Purpose: Marquette University - Valley Field Planned Development Agreement

We are requesting a minor modification to the Detailed Planned Development (DPD) known as Valley Fields to allow a corporate signage on the Seasonal Air Supported Structure. This DPD was established by the Common Council on May 30, 2007 as file no. 070057 to permit the outdoor recreation facility, and subsequently amended on July 27, 2010 as file no. 100188 to allow construction of a new soccer team facility to the east of the existing grandstand. A minor modification to the DPD was approved on July 2, 2013 as file no. 130371 to permit construction of new spectator seating. Most recently, a minor modification to the DPD was approved on March 28, 2017 as file number 161712 to permit a 30ft x 30ft banner display on the North and East elevations of the Seasonal Air Supported Structure.

Marquette University Seasonal Air Supported Structure

1 NORTH ELEVATION - PROPOSED BANNER
SCALE: 1/16"=1'-0"

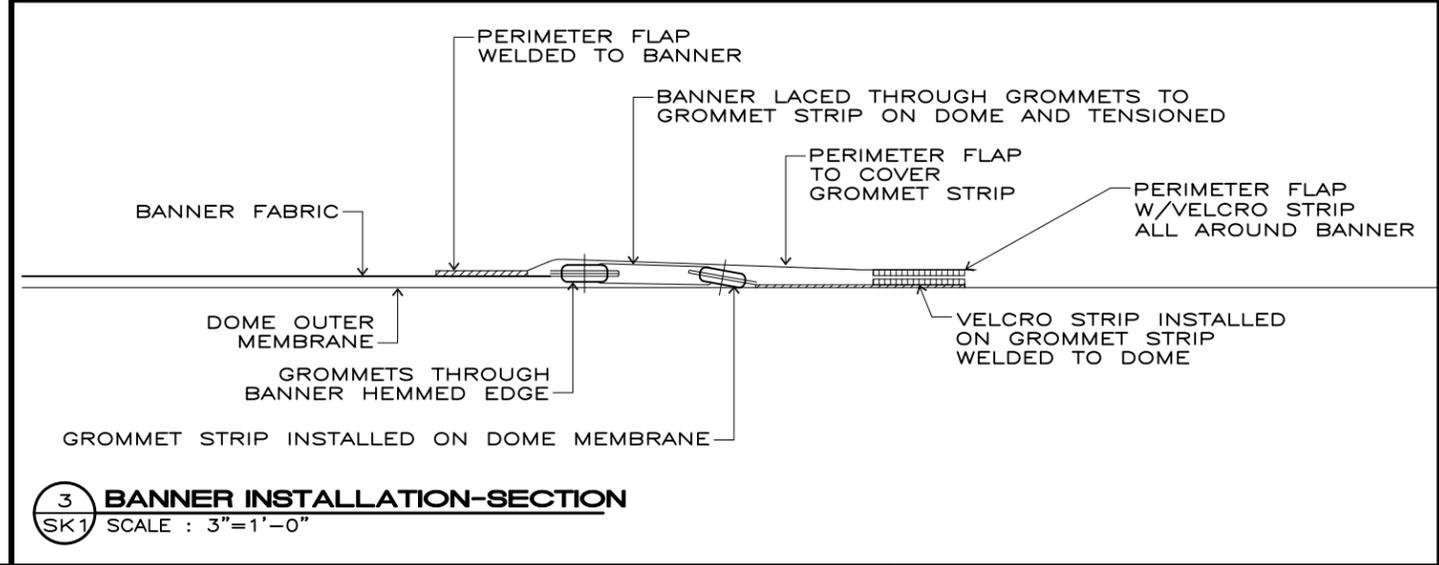
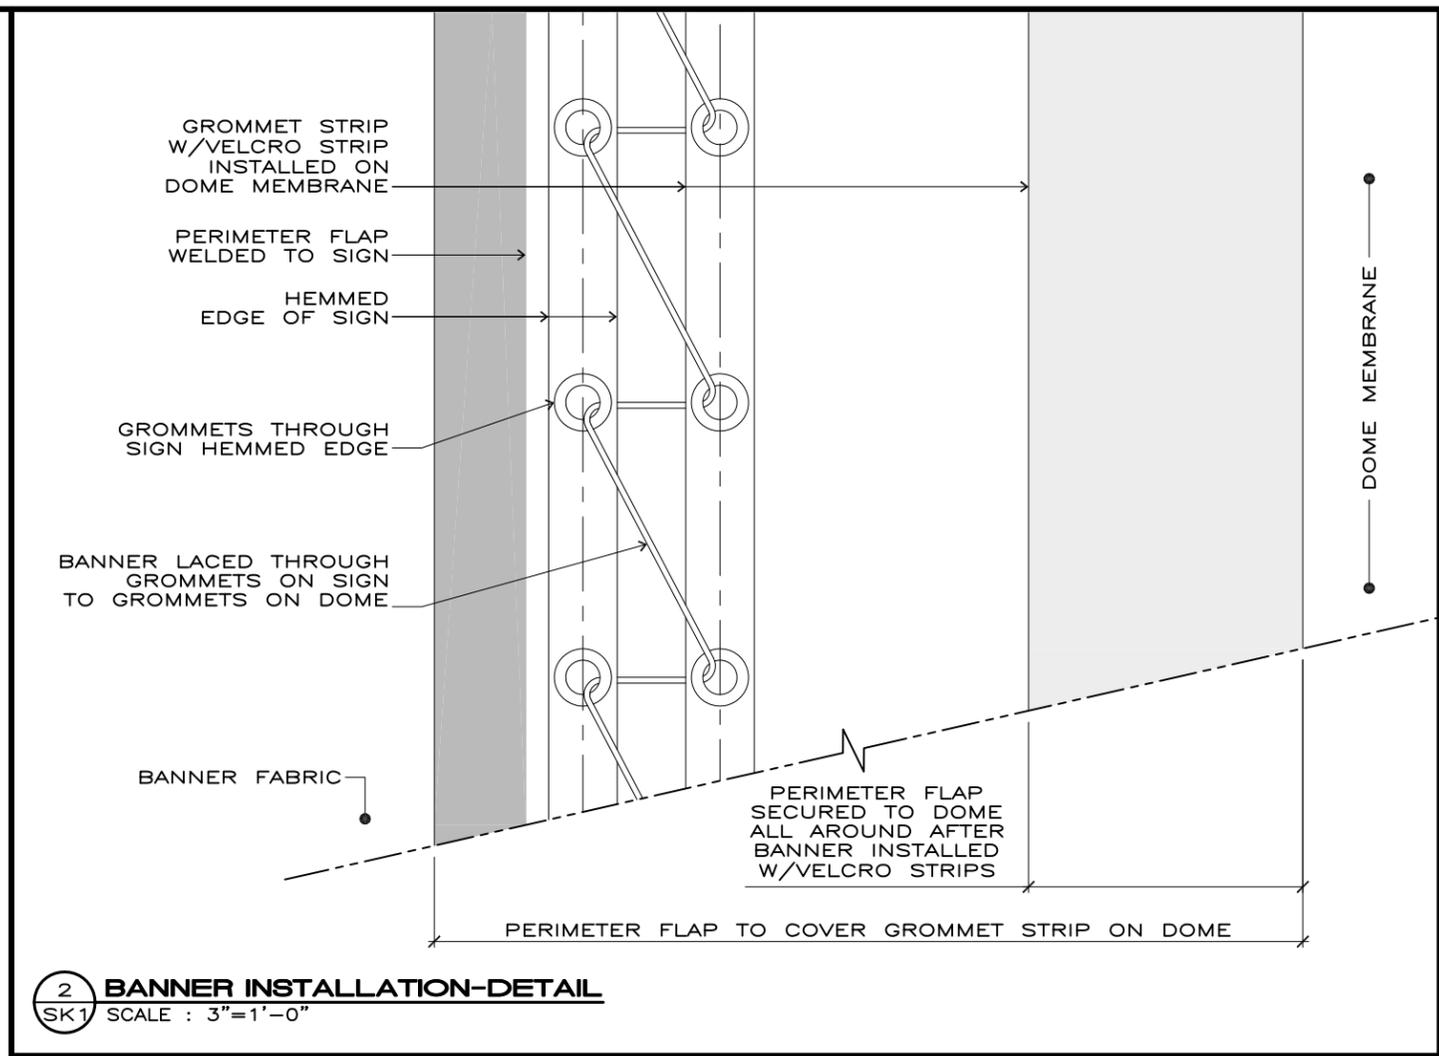
The intent of this minor modification is to allow the university to replace the existing banner on the North side of the Seasonal Air Supported Structure (ie – dome) with a new larger Marquette University banner that includes sponsor recognition. The existing Marquette University banner on the East elevation would not be modified. The banners would be connected/interlaced with the fabric of the dome system similar to the existing Marquette University – MU logo banners.

The current Planned Development Agreement for Valley Fields limits the type/size of signage and fabric banners. The existing Marquette University logo banners are each approximately 30ft x 30ft in size. The intended size for the new MU – Town Bank banner on the North elevation is approximately 30ft x 90ft. We have included a photo of the existing North banner and a rendering of the proposed modification with this application.
